SITE PLAN (AP ZONE)
3150 BEAR STREET, COSTA MESA CA 92629

EASEMENT PLAN
3150 BEAR STREET, COSTA MESA CA 92629

BUILDING AND SAFETY (B&S): EVENT SPACE SUITE 100B USE FOR WEDDING AND CEREMONY

SECOND FLOOR PLAN
SCALE: 3/32" = 1'-0"

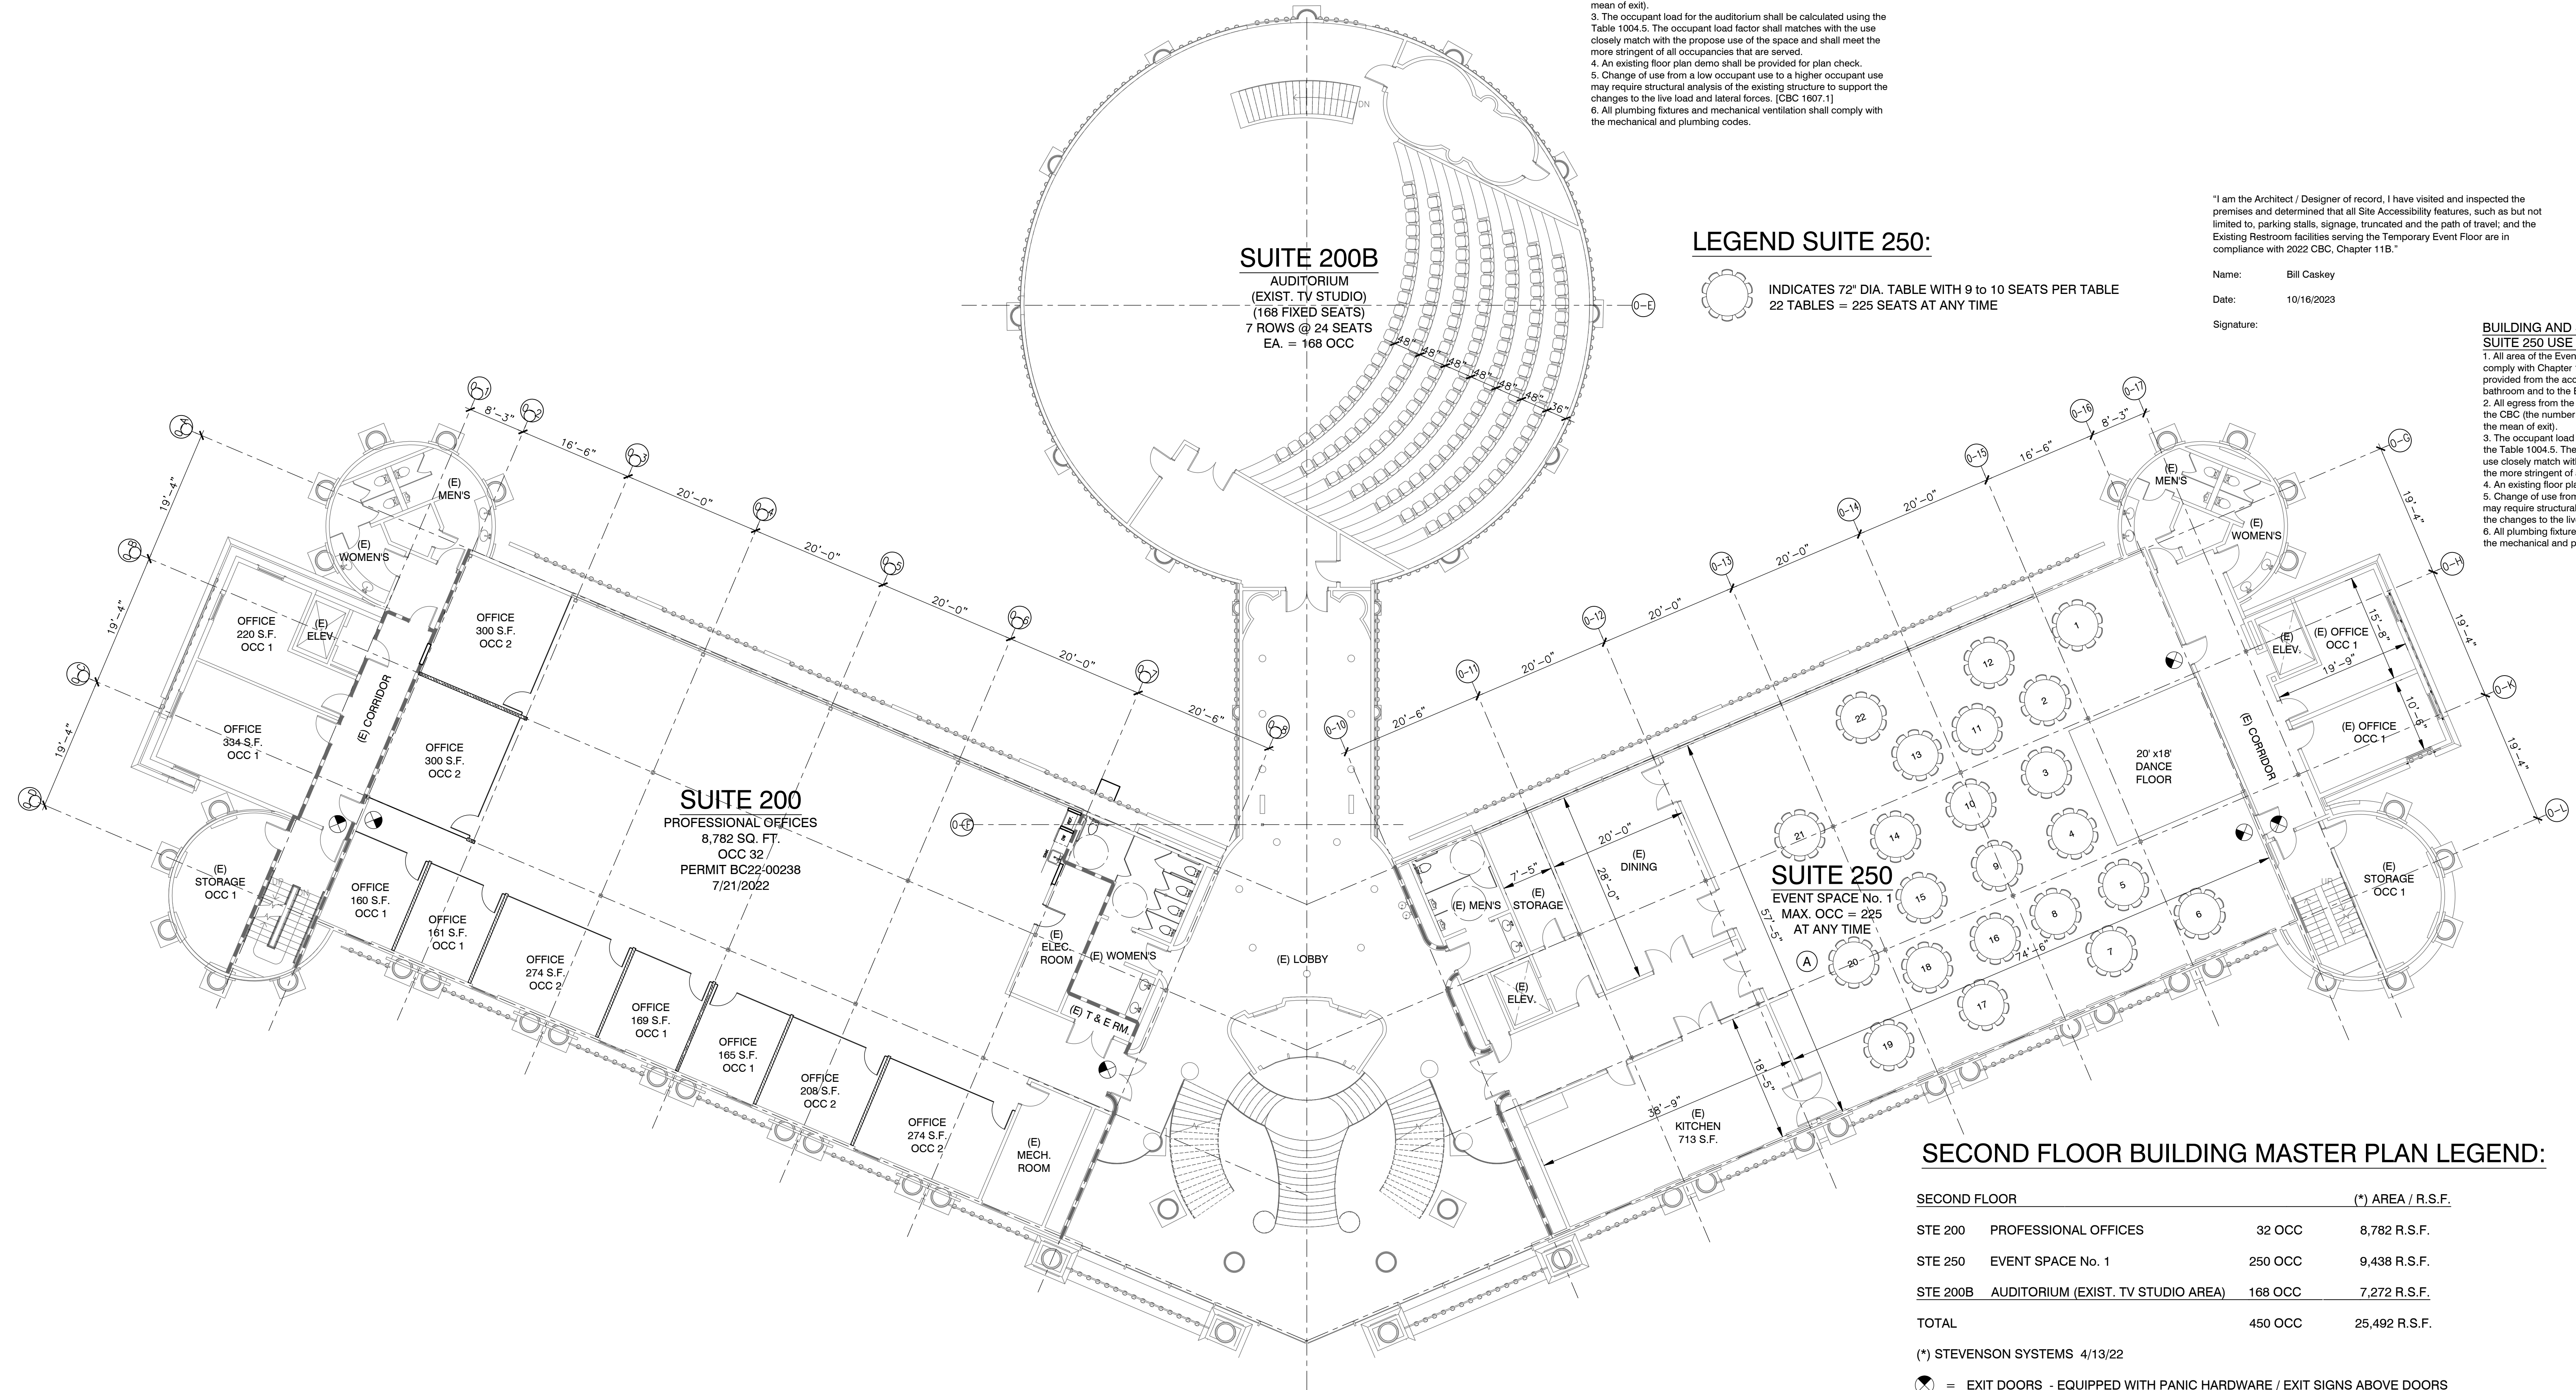
BUILDING AND SAFETY (B&S): EVENT SPACE SUITE 200B USE FOR SEMINAR, CORPORATE FUNCTION, PRODUCTS UNAVAILABLE, AND SILENCE AUCTION.

1. All area of the auditorium shall be accessible for wheelchair comply with Chapter 11B. An accessible path-of-travel shall be provided from the accessible parking space to the accessible bathroom and to the auditorium. [CBC 11B-202.3]

2. All egress from the auditorium shall comply with Chapter 10 of the CBC (the number of exits, width of the exit, travel distance, and the mean of exit).

3. The occupant load for the auditorium shall be calculated using the Table 1004.5. The occupant load factor shall matches with the use closely match with the propose use of the space and shall meet the more stringent of all occupancies that are served.

4. An existing floor plan demo shall be provided for plan check.
5. Change of use from a low occupant use to a higher occupant use may require structural analysis of the existing structure to support the changes to the live load and lateral forces. [CBC 1607.1]

6. All plumbing fixtures and mechanical ventilation shall comply with the mechanical and plumbing codes.

BUILDING AND SAFETY (B&S): EVENT SPACE SUITE 250 USE FOR WEDDING AND CEREMONY.

1. All area of the Event Space shall be accessible for wheelchair comply with Chapter 11B. An accessible path-of-travel shall be provided from the accessible parking space to the accessible bathroom and to the Event Space. [CBC 11B-202.3]

2. All egress from the Event Space shall comply with Chapter 10 of the CBC (the number of exits, width of the exit, travel distance, and the mean of exit).

3. The occupant load for the Event Space shall be calculated using the Table 1004.5. The occupant load factor shall matches with the use closely match with the propose use of the space and shall meet the more stringent of all occupancies that are served.

4. An existing floor plan demo shall be provided for plan check.
5. Change of use from a low occupant use to a higher occupant use may require structural analysis of the existing structure to support the changes to the live load and lateral forces. [CBC 1607.1]

6. All plumbing fixtures and mechanical ventilation shall comply with the mechanical and plumbing codes.

"I am the Architect / Designer of record. I have visited and inspected the premises and determined that all Site Accessibility features, such as but not limited to, parking stalls, signage, truncated and the path of travel, and the Existing Restroom facilities serving the Temporary Event Floor are in compliance with 2022 CBC, Chapter 11B."
